Access Compliance Report

Public Rights-of-Way

(Curb Ramps)

Intersection ID: 13994	Main Street: E_3RD_ST	Cross Street: S_TORRENCE_ST	Location: SW
ADA ID: DCEC1F207EA4	Ramp Type: Perp	Initial Pass/Fail: Fail	Overall Compliance: No
		Severity Score: 8.75

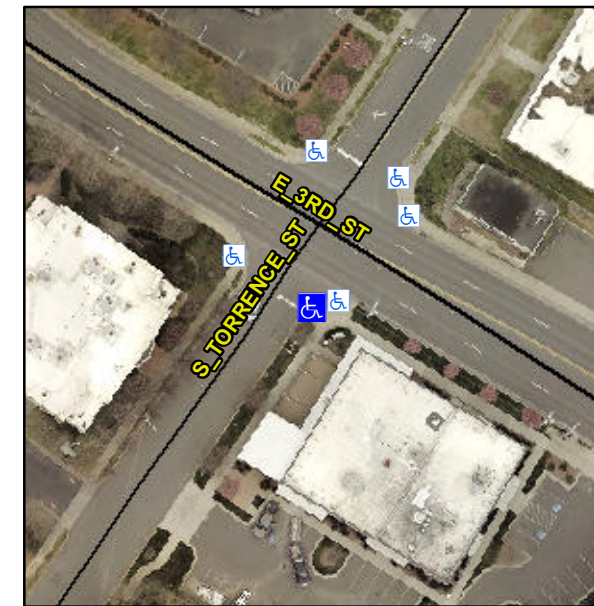
Possible Solutions:

Remove & Replace Entire Ramp.

R304.5.1

Compliance	Description	Data	Compliance	Description	Data
N/A	Ramp Length (in)	91.5	Yes	Ramp Slope (%)	7.9
No	Ramp Width (in)	37.0	Yes	Ramp XSlope (%)	0.4
N/A	Flare Type LT	N/A	N/A	Flare Type RT	N/A
N/A	Flare Slope LT (%)	N/A	N/A	Flare Slope RT (%)	N/A
N/A	Flare Traversable LT?	N/A	N/A	Flare Traversable RT?	N/A
N/A	Landing Length (in)	N/A	N/A	DWS Provided?	N/A
N/A	Landing Width (in)	N/A	N/A	DWS Contrast?	N/A
N/A	Landing Slope (%)	N/A	N/A	DWS Length (in)	N/A
N/A	Landing X Slope (%)	N/A	N/A	DWS Full Width?	N/A
N/A	Landing Curb? (Y/N)	N/A	N/A	DWS Offset (in)	N/A
N/A	Shared Landing?	N/A			
N/A	Gutter Ponding?	N/A	N/A	Gutter Slope (%)	N/A
N/A	Gutter Lip Ht (in)	1.0	N/A	Gutter X Slope (%)	N/A
N/A	Painted X Walk1?	No	N/A	Painted X Walk2?	N/A
	X Walk 1 Direction	To NW		X Walk 2 Direction	N/A
N/A	X Walk 1 Width (in)	N/A	N/A	X Walk 2 Width (in)	N/A
	X Walk 1 Slope (%)	0.8		X Walk 2 Slope (%)	N/A
	X Walk 1 X Slope (%)	1.7		X Walk 2 X Slope (%)	N/A
